Seabrook Station Unit 1 **Pre-Submittal Meeting**

License Amendment Request

Update Pressure-Temperature Limits (PTL) Curves'
Period of Applicability Based on Latest Fluence Projections

February 23, 2022

FIGURE 3.4-2

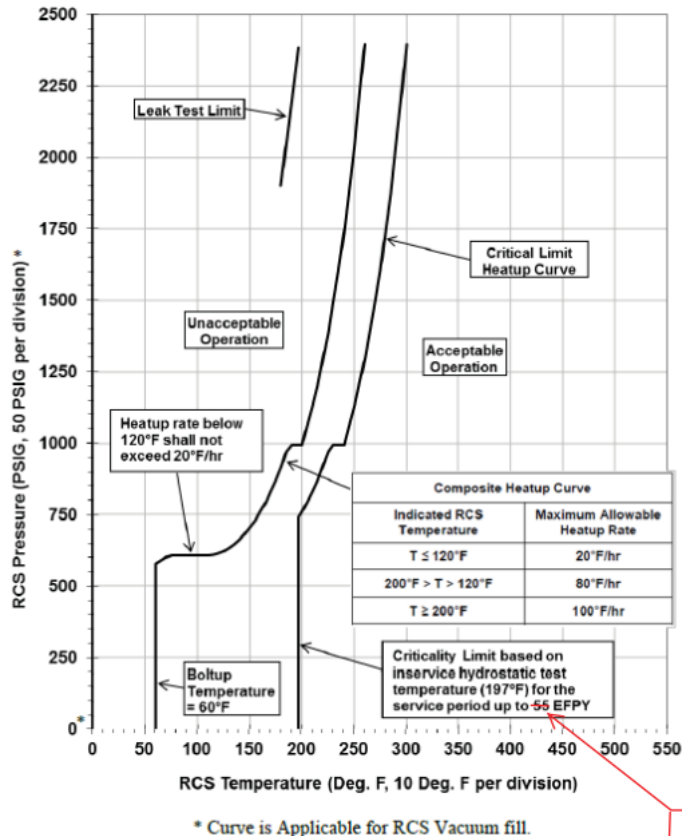
Update RCS PTL curves

- TS 3.4.9.1, Figures 3.4-2 and 3.4-3
- TS 3.4.9.3, Figure 3.4-4
- Change Period of Applicability from 55 EFPY to 52.6 EFPY where specified
- Address Non-Conservative TS per RG 1.239.
 - Currently in Seabrook CAP
 - Seabrook was at 26.46 EFPY at EOC 20 (Spring 2020)
- No other proposed changes
- Process as normal LAR

- **Results transmitted September 2021 (ML21273A113)**
 - 10 CFR Part 50, Appendix H
- **Applicable standards, guidance**
 - WCAP-17441-NP (55 EFPY PT Limit curves & fluence basis)
 - 55 EFPY fluence projection was $3.05E19$ n/cm²
- **Revised Fluence Projection**
 - WCAP-18607 Capsule “X” revised the fluence
 - 3.05 n/cm² reached at 52.6 EFPY
 - Period of Applicability
